Subject: Duke Energy Carolinas, LLC
William States Lee III Nuclear Station - Docket Nos. 52-018 and 52-019
AP1000 Combined License Application for the
William States Lee III Nuclear Station Units 1 and 2
Response to Request for Additional Information
(RAI No. 2685)
Ltr# WLG2009.07-09

Reference: Letter from Brian Hughes (NRC) to Peter Hastings (Duke Energy),
Request for Additional Information Letter No. 070 Related to
SRP 02.04.12 - Groundwater for the William States Lee III Units 1 and 2
Combined License Application, dated June 17, 2009

Lee Nuclear Station Response to Request for Additional Information (RAI)

Reference NRC RAI Number(s): 02.04.12-015

WILLIAM STATES LEE III
 NUCLEAR STATION UNITS 1 & 2
 Cross Sections of Lee Nuclear Site:
 B - B'
 FIGURE 2.4.12-205
 Sheet 3 of 4

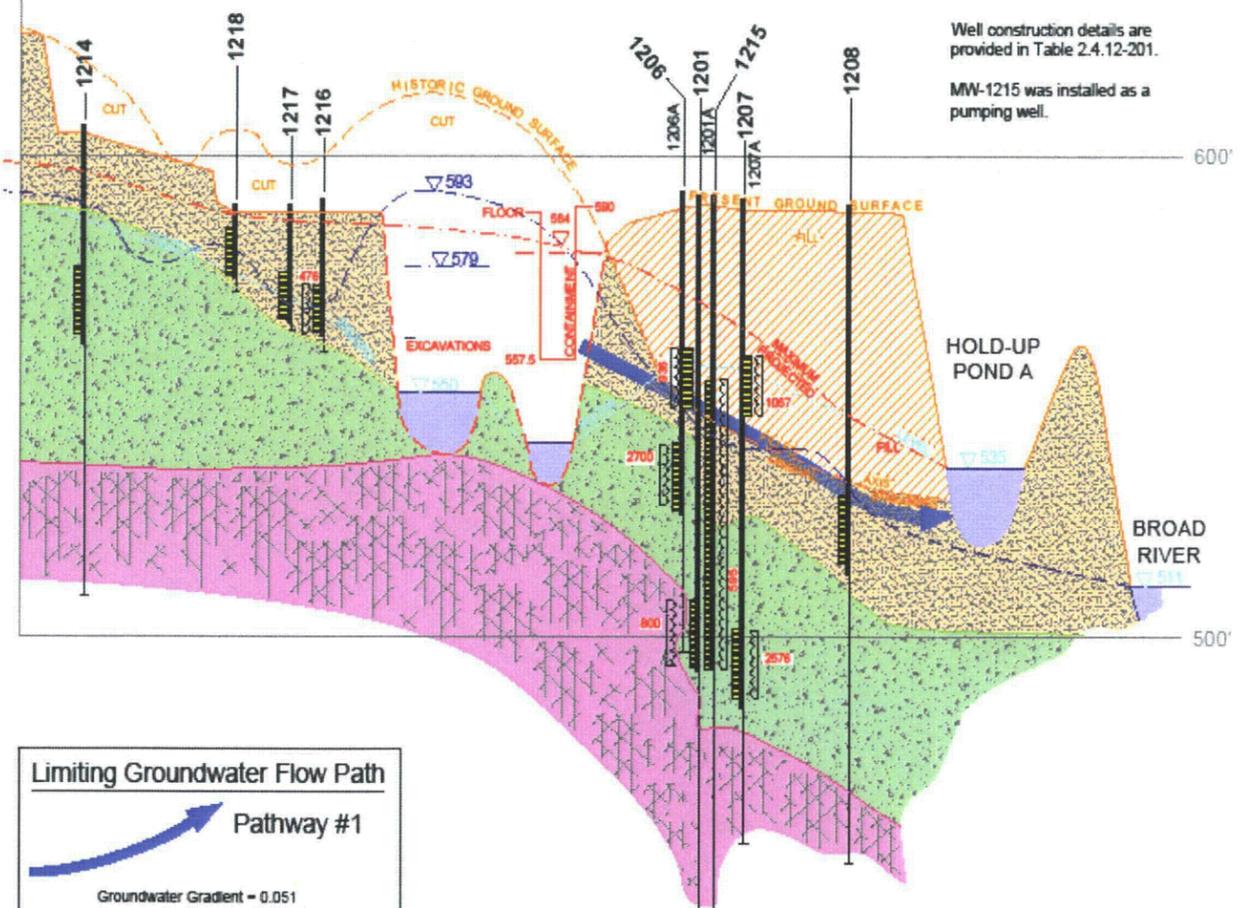
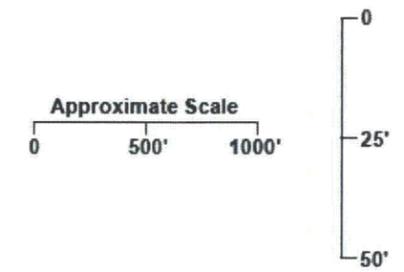
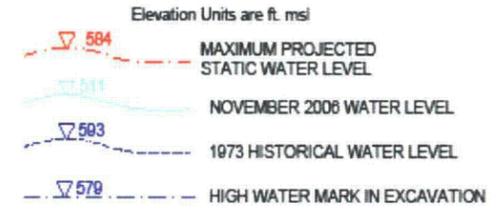
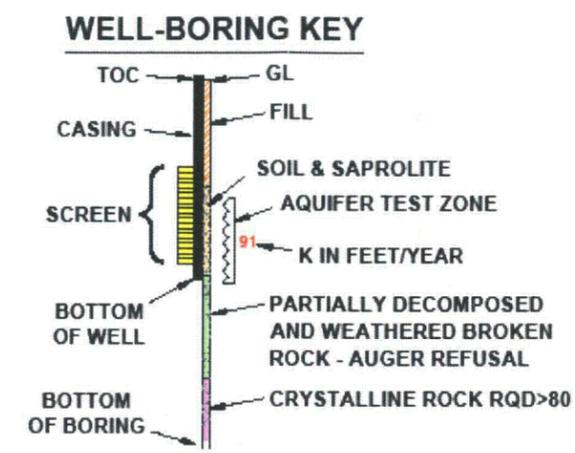
In its independent review of the geologic information, the staff determined that there was uncertainty in the geologic materials that are present along each plausible groundwater pathway. The staff also determined that the major materials – the soil, saprolite, and PWR – were all exposed in the existing excavation and that a postulated leak could enter any of these materials. Because the exact geologic structure of the Lee Nuclear site is uncertain, the applicant should assume the presence of the PWR material (the most highly conductive of the three materials) for all pathways, or justify why the materials assumed present along each pathway in the FSAR analysis are conservative.

Figure 2.4.12-205 will be revised to reflect the limiting pathway discussed above, as well as other changes discussed in the response to RAI 2.4.12-016 (this letter). FSAR Table 2.4.12-204 will be revised to reflect this RAI response more clearly. The revisions to FSAR Table 2.4.12-204 are included as an attachment to the response to RAI 02.04.12-016 (this letter). Additional revisions to FSAR Subsection 2.4.12.3.3 and 2.4.12.5 will be made, unrelated to this RAI, to correct the discussion regarding the lateral area of influence of the excavation and hydrostatic loading. These changes will be reflected in a future revision to the FSAR.

Aquifer Characteristics		
Material	K (cm/hr)	Effective Porosity
Fill Material	6.2×10^{-4}	9%
Soil and Saprolite	3.2×10^{-4}	20%
Partially Weathered Rock	1.4×10^{-3}	8%

Groundwater exists at the site as a single undifferentiated aquifer, comprised of soils, saprolite, PWR, and competent bedrock. For conservatism, the calculation of potential contaminant transport velocities used the slightly higher hydraulic conductivity and the lower effective porosity values of PWR.

Revision to FSAR Figure 2.4.12-205 (Sheets 2, 3 and 4)

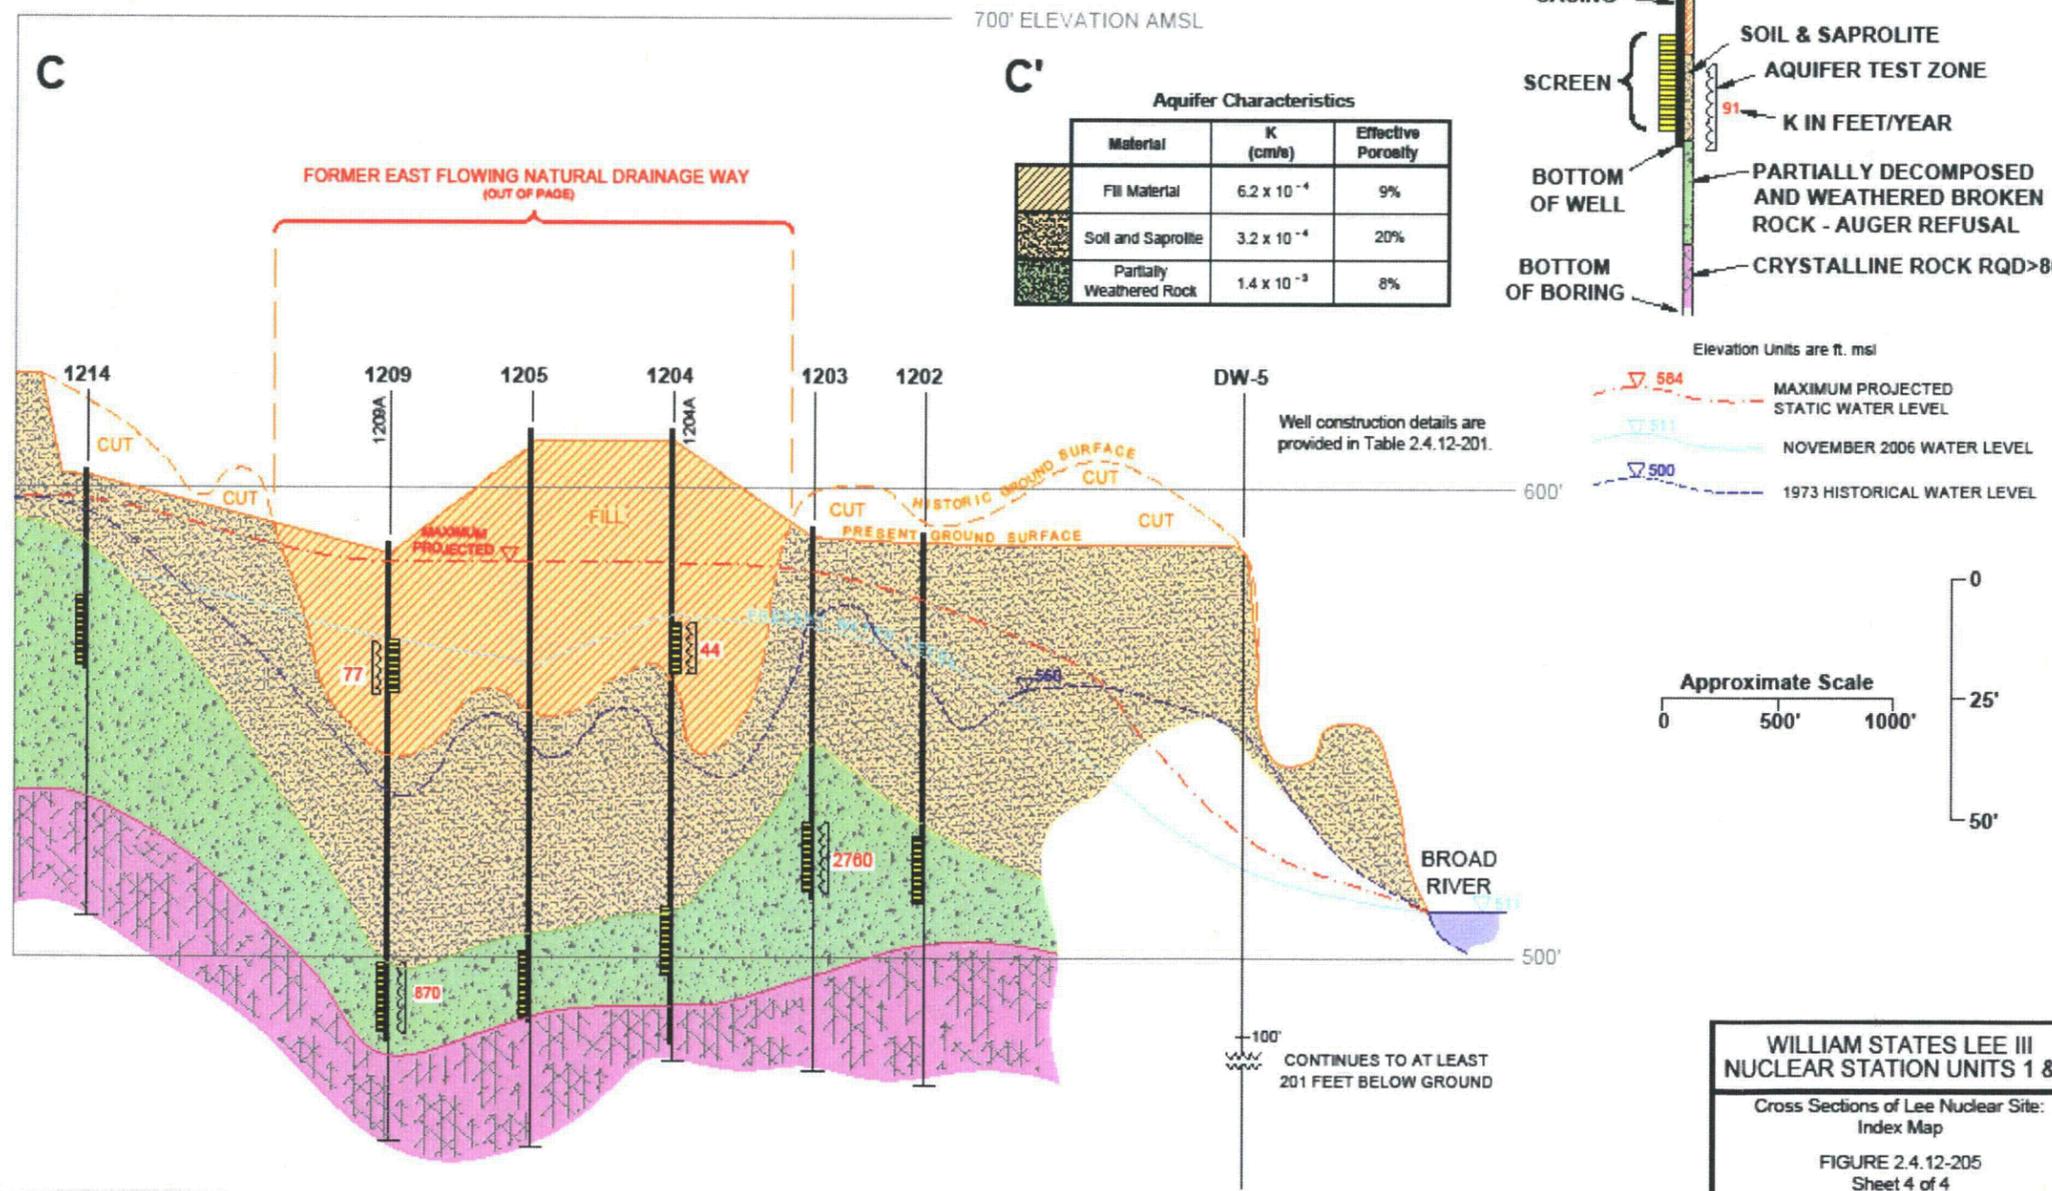
In its independent review of the hydraulic conductivity data, the staff determined that the unconsolidated material had the highest measured hydraulic conductivity, but this material did not show up in the three cross-sections provided in the applicant's FSAR. Because the value was higher than the conductivity for PWR and could, if used, yield a shorter and more conservative groundwater travel time, the applicant should identify the lateral and vertical extent of the unconsolidated material and re-evaluate the pathway analysis, or justify why the unconsolidated material is not relevant to any of the plausible groundwater pathways.

FSAR Subsections 2.4.12.2.4.1 and 2.4.12.2.4.2, FSAR Tables 2.4.12-203 and 2.4.12-204 and FSAR Figure 2.4.12-205 (Sheets 2, 3 and 4) will be revised, changing the term “unconsolidated” to “undifferentiated” or removing the term, as appropriate. Additional revisions to FSAR Subsection 2.4.12.2.4.1 and FSAR Table 2.4.12-203 will include reporting the corrected soil and rock characteristics. An additional resource cited in the text edit to Section 2.4.12.2.4.1 will also be added to Section 2.4.16. The revisions to FSAR Figure 2.4.12-205 (Sheets 2, 3 and 4) are included as an attachment to the response to RAI 02.04.12-015 (this letter). The identified changes will be incorporated in a future revision of the Final Safety Analysis Report.

Lee Nuclear Site
 Groundwater Elevations for MW-1214

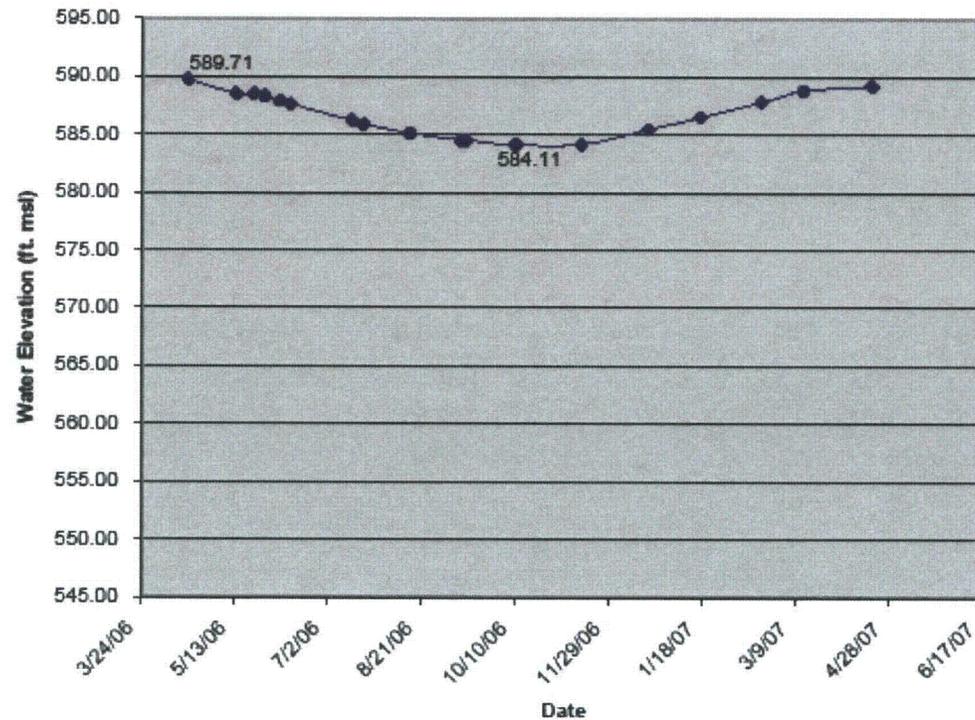
In its independent review of the precipitation and groundwater data, the staff determined that precipitation was below normal during the monitoring period such that groundwater responses were potentially smaller than would be expected during wetter years. In addition, currently ongoing excavation dewatering keeps groundwater levels artificially lower than normal such that seasonal variations are muted. Therefore, the range of groundwater variation to be expected could be greater and the estimate of the highest water table level could be higher. The staff also determined that there was insufficient information to determine a) how groundwater levels would respond spatially once groundwater conditions were restored after the cessation of construction dewatering and b) how post-dewatering groundwater conditions would alter the identification of plausible groundwater pathways. Because the groundwater data collected during the monitoring period are insufficient to describe groundwater conditions after the construction dewatering ceases, the applicant should conduct a groundwater flow analysis to provide sufficient support for determining the plausible post-construction groundwater elevations in the vicinity of the nuclear island and for determining the post-construction groundwater pathways for the radionuclide transport analysis in Section 2.4.13 of the FSAR. The analysis should include estimates of post-construction recharge conditions across the Lee Nuclear Site, normal and wetter-than-normal precipitation conditions (to yield maximum water table rise), and plausible pathway properties.

Annual precipitation for the GSP station for the three-year period from 2003-2005 was 111.3 percent of normal for this extended period. These above normal precipitation trends continued until the beginning of the 2007-2008 drought in April 2007. Site groundwater elevation data from April 2006, prior to the drought period and when groundwater monitoring was initiated at the Lee Site, through March 2007 is provided for MW-1214 (Attachment 2). This well can be considered a "background" location in that it is approximately 1160 ft upgradient and south of the south wall of the excavation and within the same groundwater flow region of the site as the power block (between the north and south groundwater divides). MW-1214 shows no influence of the dewatering activities and provides a valid reference point for the determination of "natural" upgradient groundwater levels and gradients across the site from south to north. MW-1214 shows springtime peak groundwater elevation of approximately 589-590 ft msl and late fall groundwater elevations of approximately 584 ft msl, a seasonal fluctuation of 5.60 ft. (Attachment 2).

Max. Elev.	589.71
Min. Elev.	584.11
	<u>5.60</u> Seasonal Groundwater Table Fluctuation (ft)
